P802.1CQ-D0.8, Comment 3 - Supportive Slides -

Introduction

Motivation: New FDB Formats

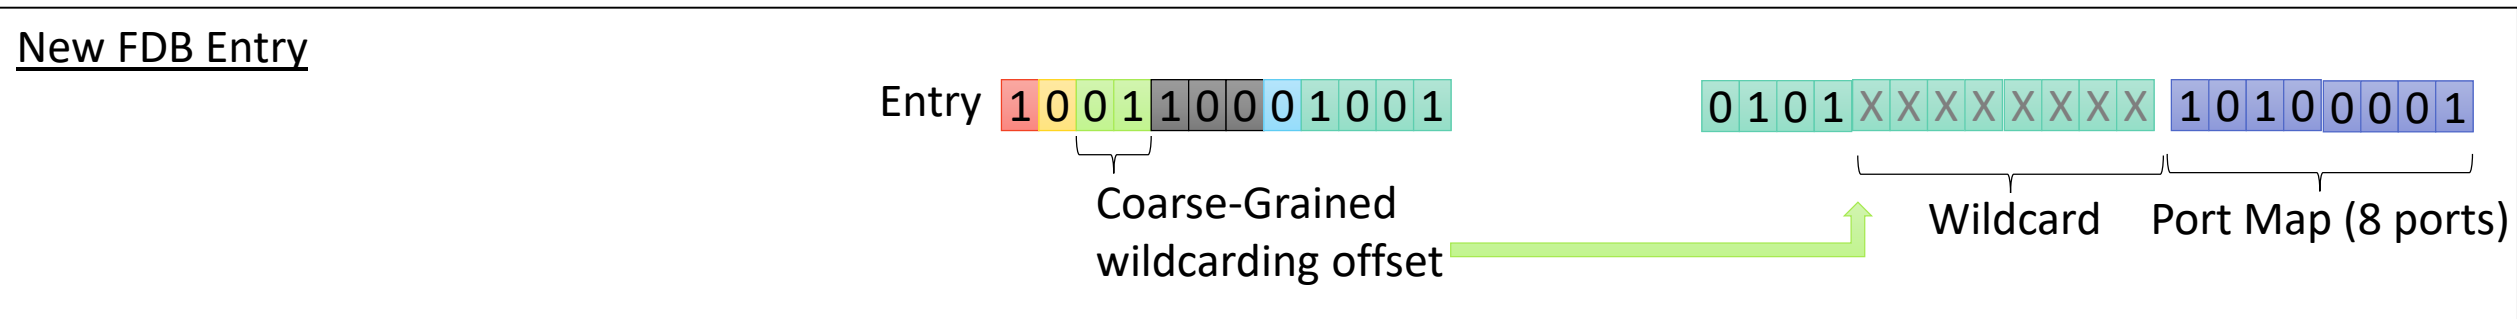
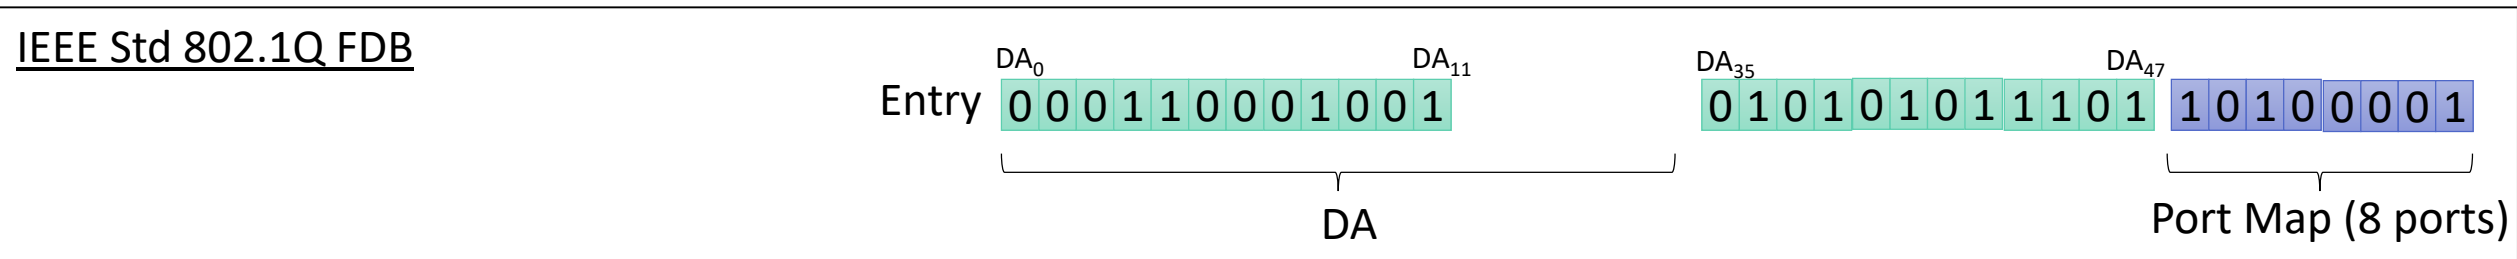
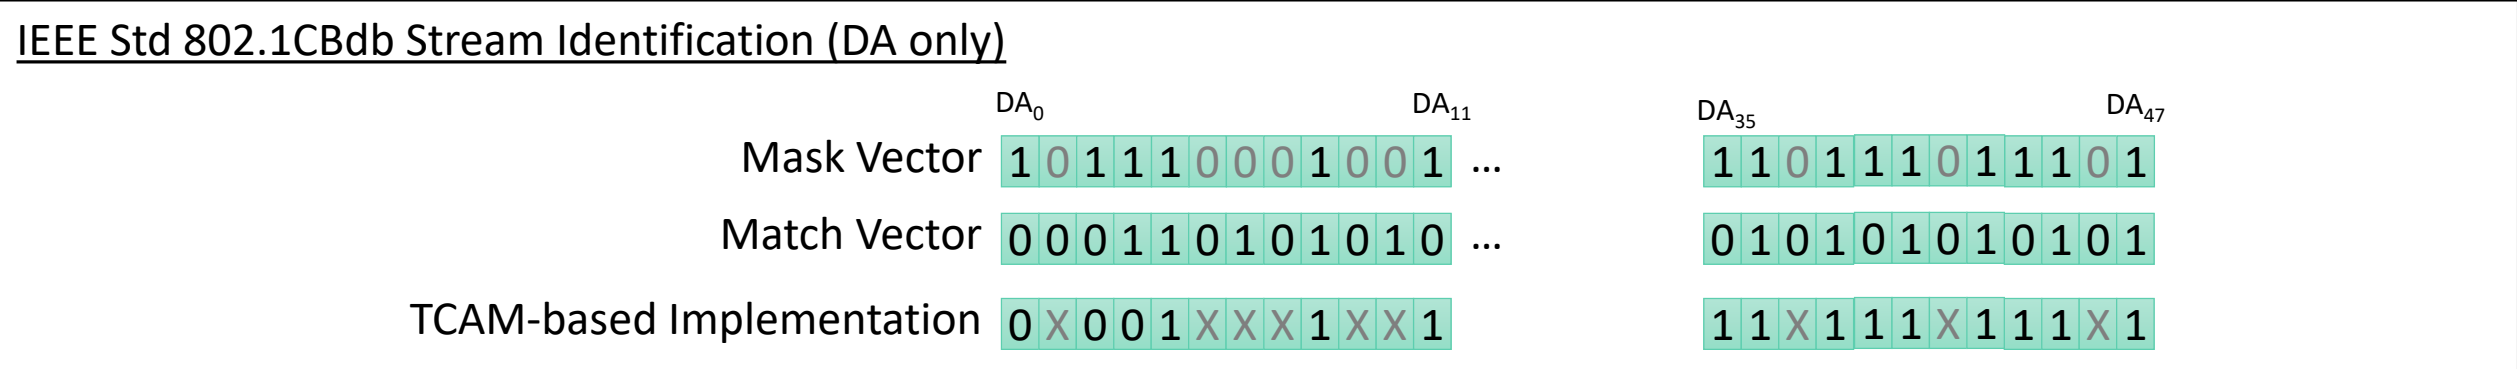
- The current FDB entry types (802.1Q) are essentially composed of two components (VLANs skipped):
 1. A MAC address, the entry with an **exact DA match** is selected (bit-by-bit comparison)
 2. A port map, one bit per port: 1→transmission port; 0→no transmission port
- MMRP (802.1Q) supports address blocks. But this is not reflected in the FDB, and not suited for fast startup.

• The Issue

- FDB-size matters in cost sensitive markets - with one FDB entry per Stream, the FDB capacity **requirement** can become ... significant.

• The Idea

- **Wildcarding of coarse-grained MAC address bit blocks** in a **single FDB entry** appears promising ...
- A **block** of streams could be covered by a single FDB entry (**relaxed FDB requirement**)
- Nothing new in Bridges:
 - Several TCAM-based implementations should be already provide the capability (fine-grained), **but**
 - the capability is not standardized, and
 - would not be friendly to hash-based FDB implementations
 - P802.1CBdb introduced mask-and-match filter
 - **hash-based unfriendly** (fine-grained)
 - **Unavailable for FDB** forwarding port lookup
- Coarse-grained block-wise wildcarding may mitigate “unfriendliness” for hash-based implementations
 - Requires a **indicator for coarse-grained wildcarding and offset**
